REVISIONS		
DATE	BY	DESCRIPTION
9-18-90	RHJ	Add 6"WHC, 6"TEE & 6"VALVE
11-1-91	KAP	⚠ Addition of Pathway
1-6-93		AS-BUILT
12-9-20	ALC	ADD EXTERIOR DOOR & CONCRETE PAD ③
11-17-22	NJR	④ NEW STORAG BUILDING ADDED

FOR STORAG BLDG. ONLY
⚠ CERTIFICATION
I hereby certify that this redline revision was prepared by me, and that I am a duly authorized Surveyor #11049 expires: 2-10-23.
STATE OF MARYLAND — M. NAJIB ROSHAN — 11049 — REGISTERED PROFESSIONAL LAND SURVEYOR
12-13-2022
M. NAJIB ROSHAN, NJRE & ASSOC.

SITE, GRADING AND SEDIMENT CONTROL PLAN
WILDE LAKE INTERFAITH CENTER
BUILDING ADDITION
VILLAGE OF WILDE LAKE - SECTION 10 - AREA 4
T.M. 30
5 ELECTION DISTRICT — HOWARD COUNTY, MARYLAND

SDP-90-76

PLAN
SCALE: 1"=40'

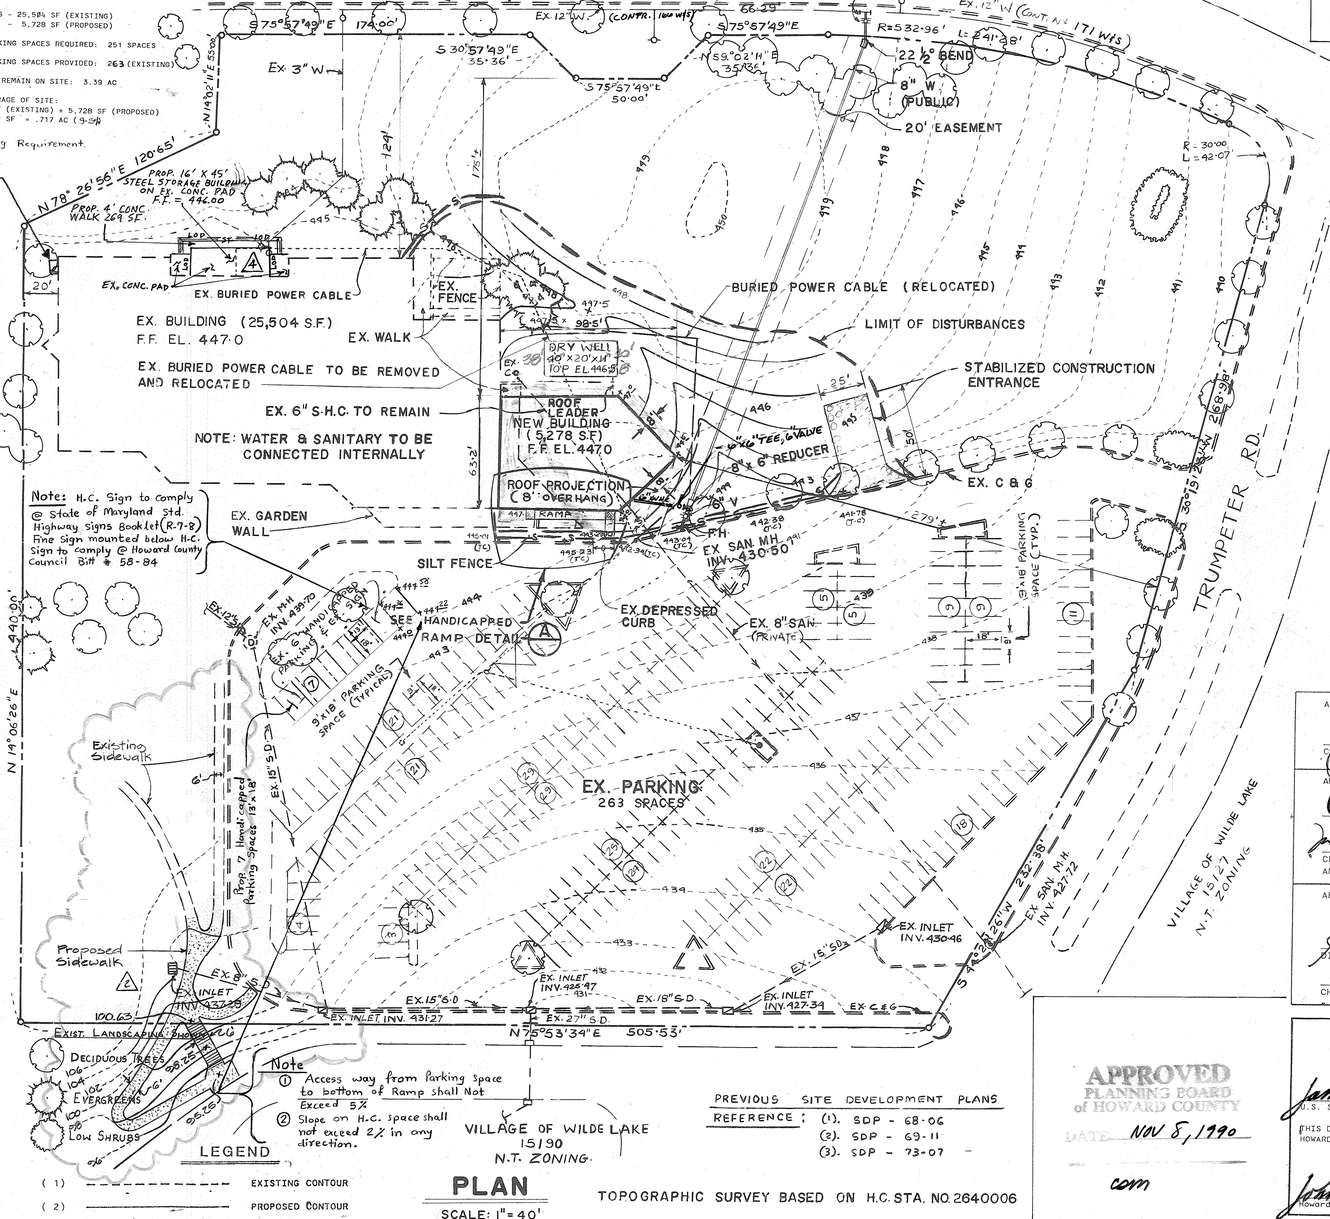
NOTES:
1. TOTAL AREA PROPOSED TO BE DISTURBED = 1.197 SET.
2. NEW IMPERVIOUS AREA ADDED = 269 SFT.
3. PROPOSED SILT FENCE LENGTH = 72'
4. THE CUMULATIVE L.O.D. OF 1,197 SFT IS EXEMPT FROM PROVIDING STORMWATER MANAGEMENT. ANY FUTURE CUMULATIVE INCREASE EXCEEDING 5,000 SFT WILL REQUIRE STORMWATER MANAGEMENT BE PROVIDED.
